**Response in respect to Regulation 28 report to prevent future deaths -
Investigation into the death of Mr Marcus Szigetvari.**

I refer to your Regulation 28 Report dated the 14th November 2014 in respect to the above investigation and in particular note under section 6, the requirement of the Council to consider traffic lights to be installed at the junction of Llanwono Road and the A4233. In response to this requirement I submit the following comments;

Figure 1 / 2 : Ghost Island Junction (para 1.15)

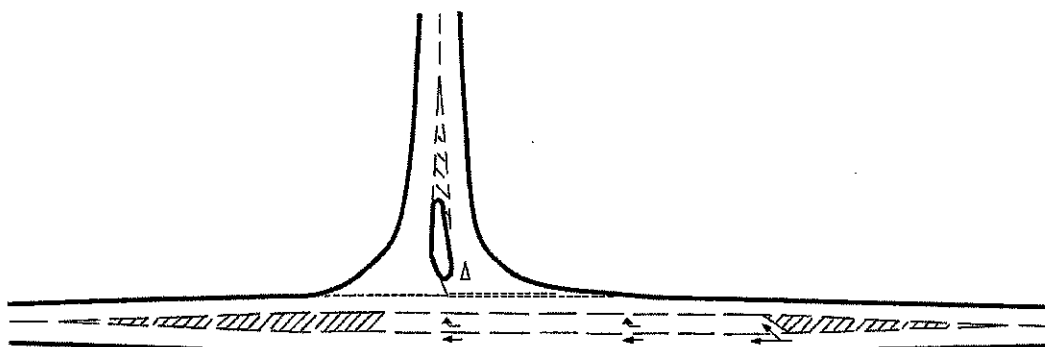
DMRB sets out the various types of priority junction that may be used and the factors that must be considered in order to determine the correct layout for the location. Whilst there are a wide range of factors that must be considered, a key consideration is major and minor arm traffic flow (traffic using the junction). Having taken account of these factors a Ghost Island Priority Junction was considered appropriate for this

location. The general arrangement of a Ghost Island can be seen below in figure 1 / 2 which is an extract from DMRB and is consistent with the road layout currently in situ which is also shown below in the aerial photograph.

Figure 2/2 : Approximate Level of Provision of T-junctions on New Single Carriageway Roads for Various Major and Minor Road Design Year Traffic Flows (paras 2.2, 2.14)

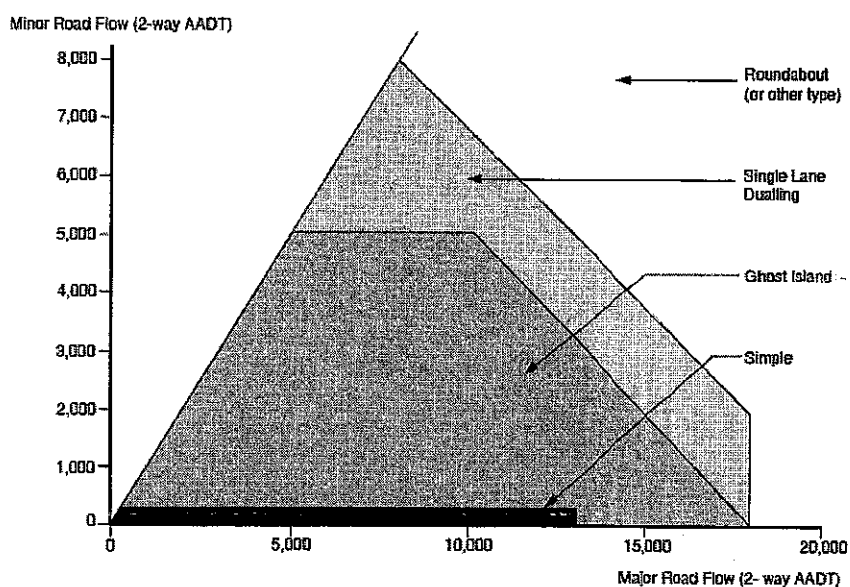
Figure 2/2 below, again an extract from the DMRB gives an indication why a Ghost Island junction is considered appropriate at this location. For example, whilst design year traffic flows (estimated from traffic models) would have been used to determine the correct junction layout to be used during the design process, recent traffic counts taken at this junction can be fed into the graph in fig. 2 /2 to assess the continued appropriateness of this junction arrangement.

With two way Annual Average Daily Traffic (AADT) flows of 8092 vehicles on the A4233 ('Major Road Flow') and two way Annual Average Traffic Flows of 2275 vehicles on Llanwono Road ('Minor Road Flow'), when plotted on the graph the point of intercept (*) clearly indicates that the use of a Ghost Island Priority junction is the most appropriate junction type for this location given its level of usage.
